Johnson Morehead School Subdivision

City of El Paso — City Plan Commission — 2/22/2018

SUSU18-00002 — Major Combination

Confetti Drive

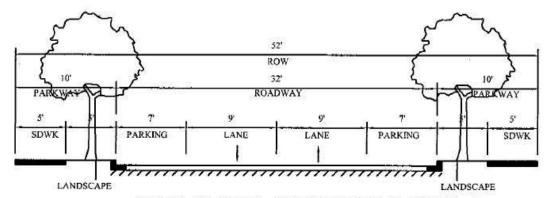
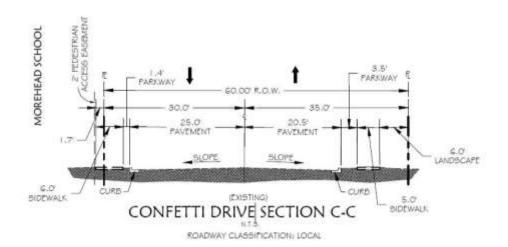
The DSC requires a 10' parkway with a 5' landscape buffer and 5' sidewalk.

The applicant proposes to preserve the existing configuration which includes a 1.4' unlandscaped buffer (adjacent to the curb), and a 6' sidewalk. In addition, the applicant proposes to dedicate a 2' pedestrian access easement to protect the entire sidewalk, as currently, the ROW ends more or less in the middle of the sidewalk.

Staff does not support the proposed exception requests.
